BSI Scope Final Design Changes

Arup Final Design Kick-Off Meeting

November 7, 2017

CR ROOM LAYOUT PHASE 4

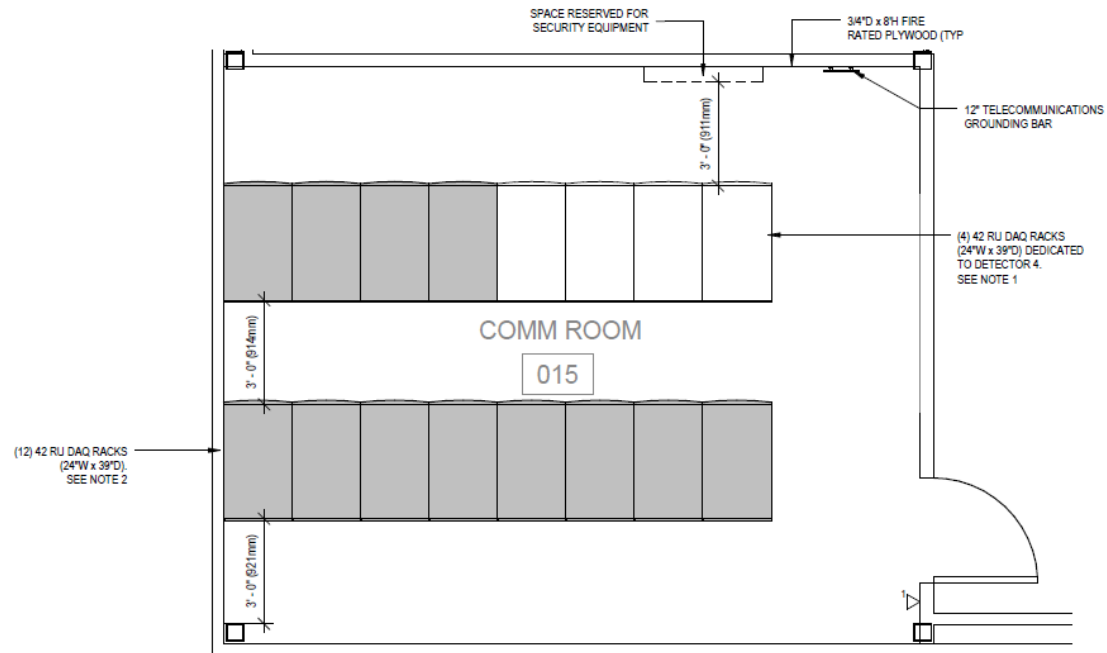
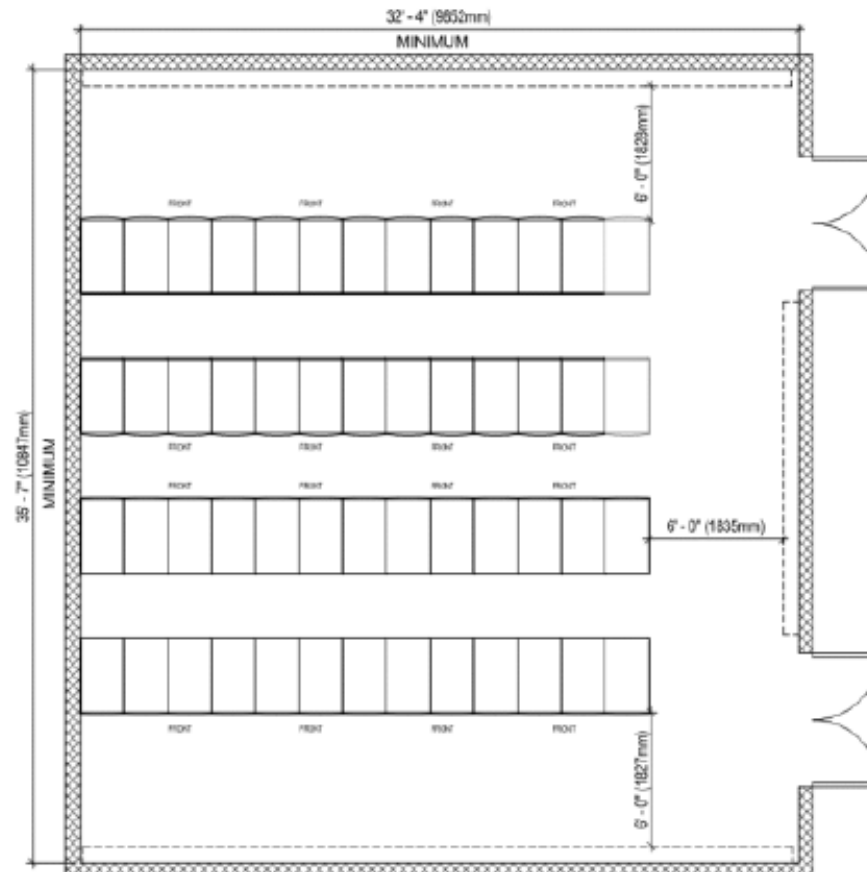
- The Current Preliminary Design calls for a total of 16 racks in the CUC Communication room

- The Final Design requires a total of 52 racks in the CUC Communication room

Pre Excavation design for
Piping in Shaft Services
compartment at 305

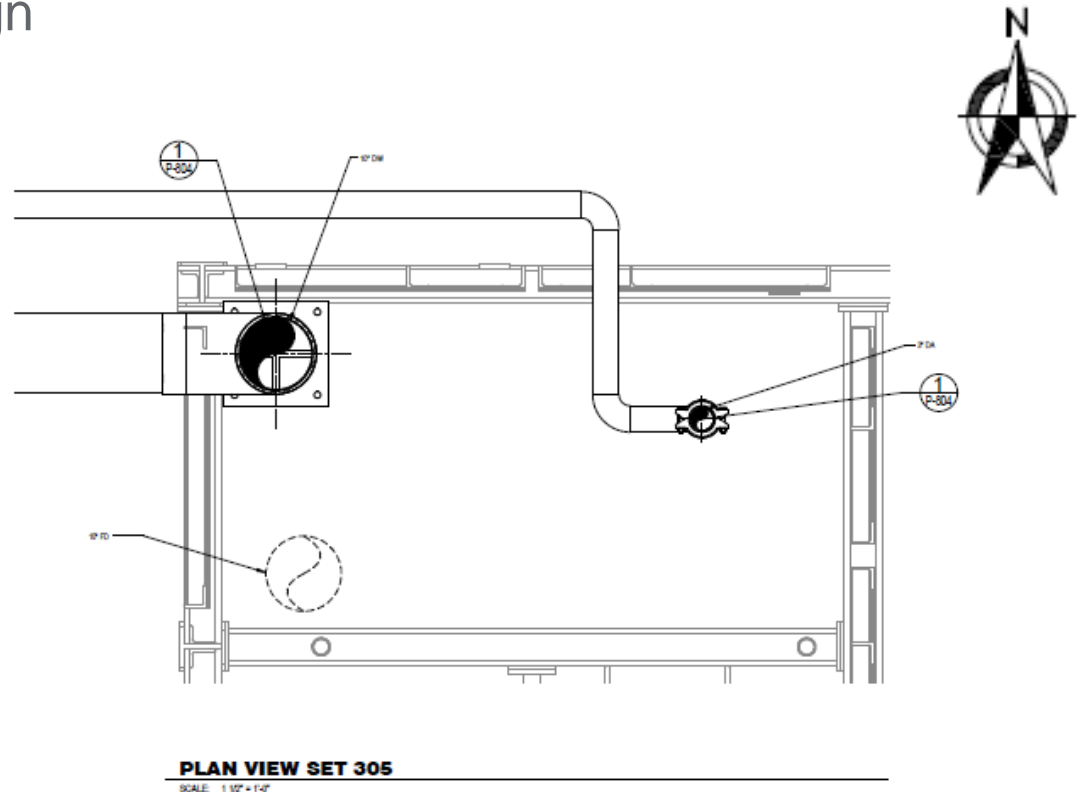
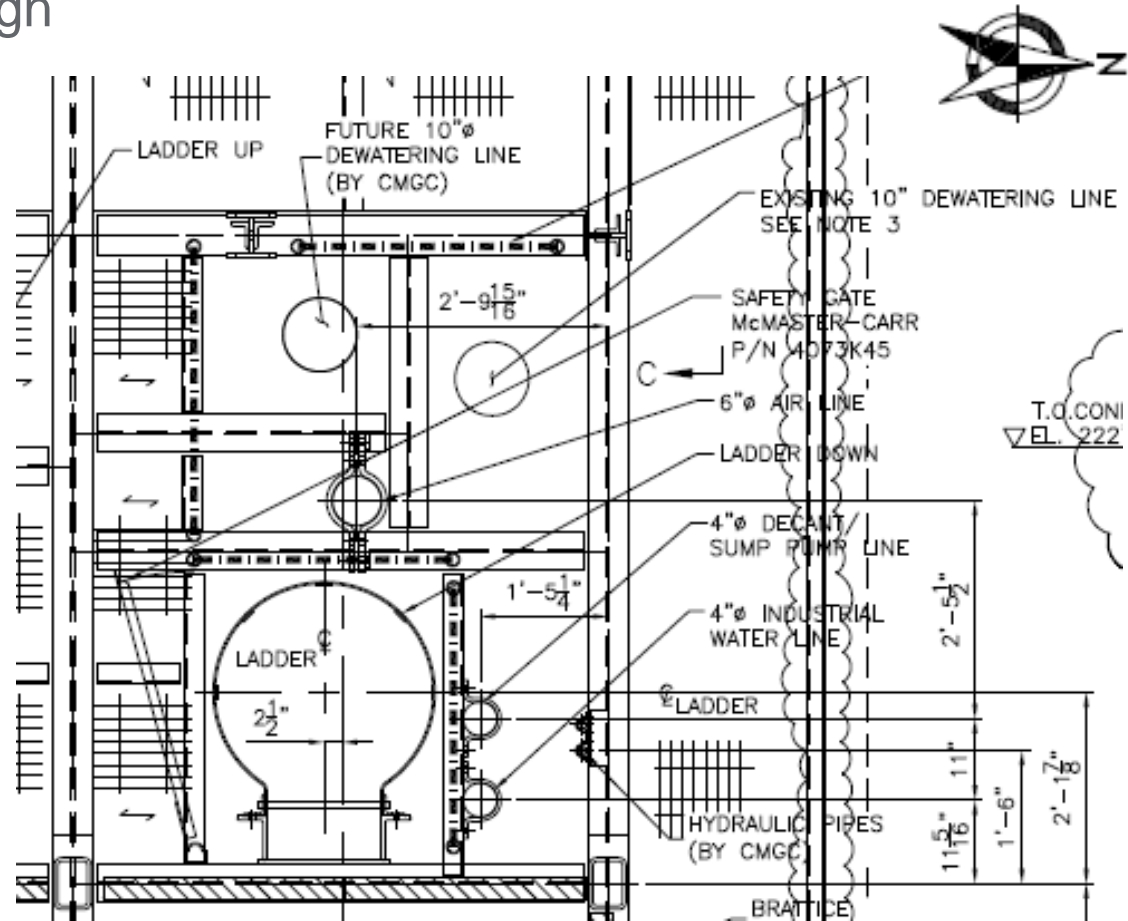
- Modifications to the Shaft Set Steel design have been completed for sets 291 – 308. All Plumbing drawings need to be updated to incorporate the final design

- Modifications to the Shaft Set Steel design have been completed for sets 291 – 308. All Plumbing drawings need to be updated to incorporate the final design
